Subject: Limerick Generating Station Units 1 and 2
Requests For Additional Information Relating
To Supplementary Cooling Water Supply

Limerick Generating Station
Units No. 1 and 2

Responses To Requests For Additional Information (RAI)
Relating To Supplemental Cooling Water Supply

FIGURE E 240.24-4

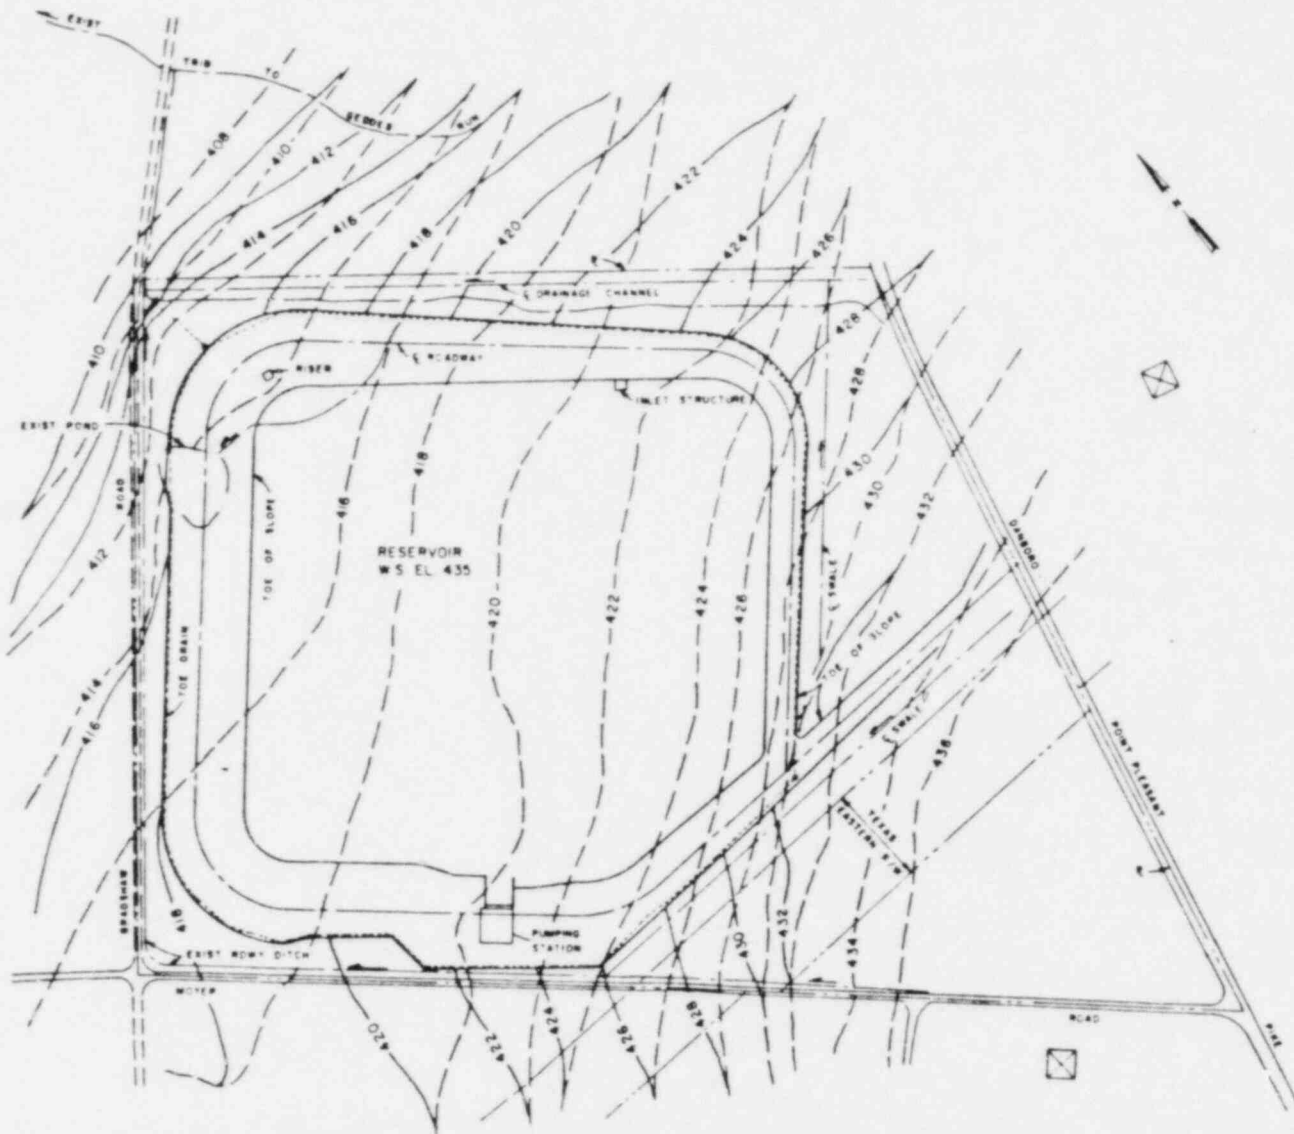
- a) A drawing(s) of the reservoir showing dimensions, water level, impervious liner, drains and filters.
- b) The thickness and permeability of the impervious liner on the bottom of the reservoir.
- c) Calculations of seepage through the reservoir and the path of the seepage (downstream or into ground).
- d) A drawing of the stratigraphy underneath the reservoir showing ambient water table elevation, potable aquifers, confining layers, and any other data pertinent to determining the potential for groundwater contamination from the reservoir.
- e) A map showing the location of groundwater users near Bradshaw Reservoir that could be affected by seepage from the reservoir.

- d) Figure E240.24-4 shows the stratigraphy below the reservoir. It should be noted that there are no confining beds or separate aquifers present. Figure E240.24-5 shows water table elevations.

FIGURE E 240.27-1

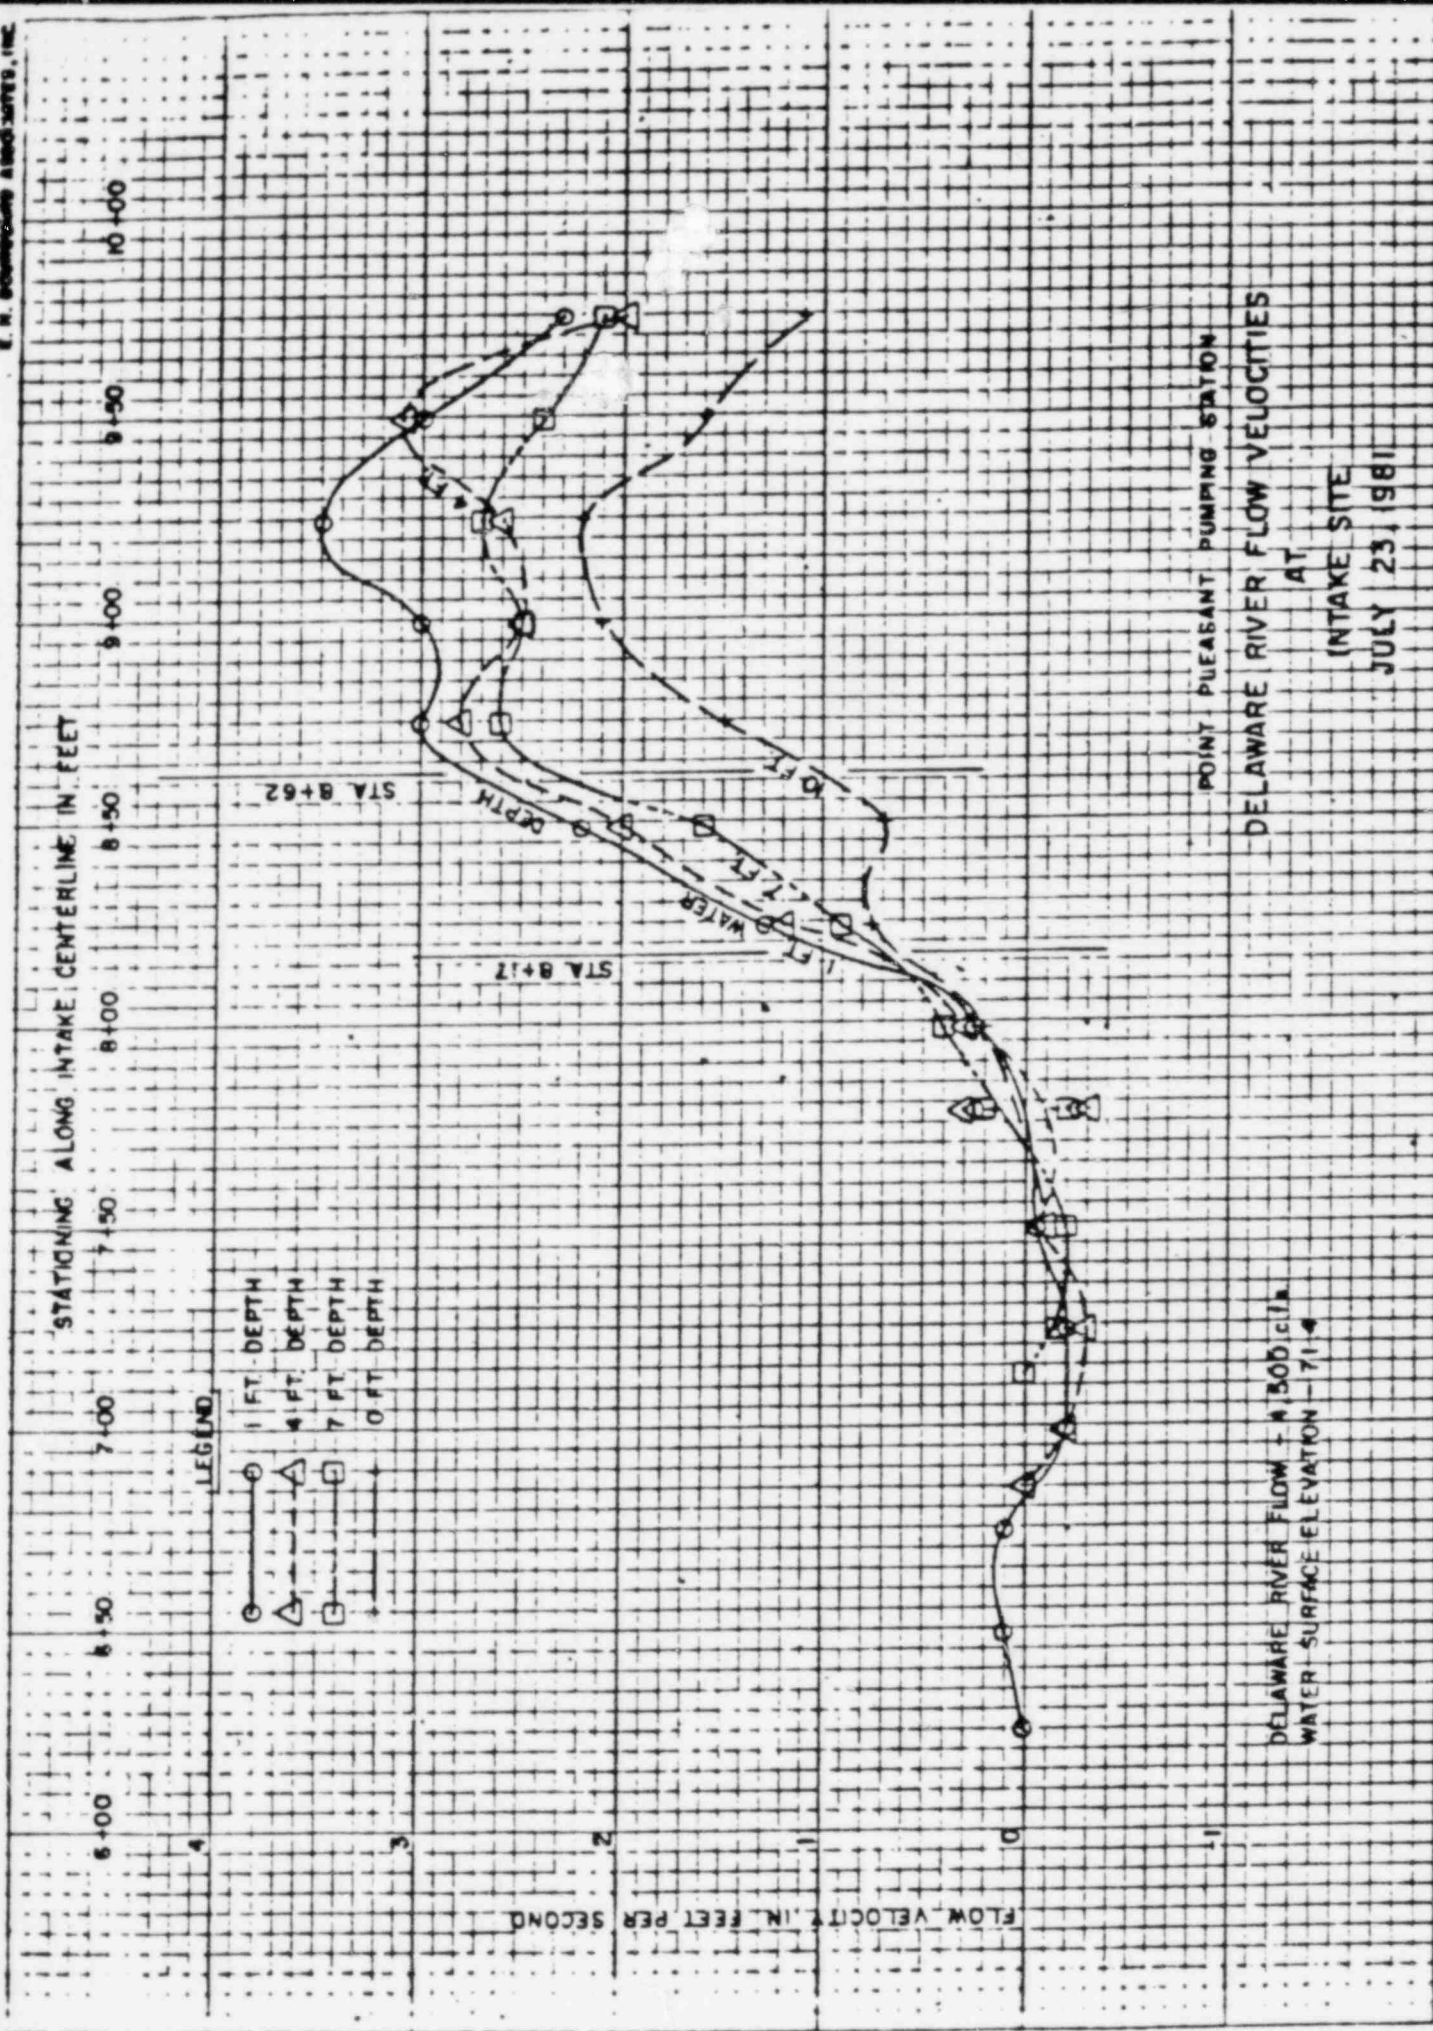
- A. Please provide all velocity profiles that were taken under various flow conditions in the Delaware River along the centerline of the intake. Please provide a cross section profile of the bottom bathymetry across the entire width of the river at this point. Where velocity measurements exist across the entire width of the river, calculate the river discharge using the measurements and compare this value with the measured discharge at the Trenton gage.
- B. Provide a curve of velocity at the intake screen versus depth over the range of flows during which you plan to withdraw water showing measured velocities, as well as calculated velocities on this curve. Describe the assumptions and data used in your calculations.

- A. Two velocity profiles were taken in the Delaware River along the centerline of the intake. One profile was taken November 7, 1980, when the river flow was approximately 3000 cfs. Figure E240.27-1 is a plot of stationing along the intake centerline versus flow velocity at 4 different depths on this date. Profile number two was taken July 23, 1981, when the river flow was approximately 4500 cfs. Figure E240.27-2 is a plot of stationing along the intake centerline versus flow velocity at 4 depths on this date. A cross section of the Delaware River at the Point Pleasant intake is shown in Figure E240.27-4.
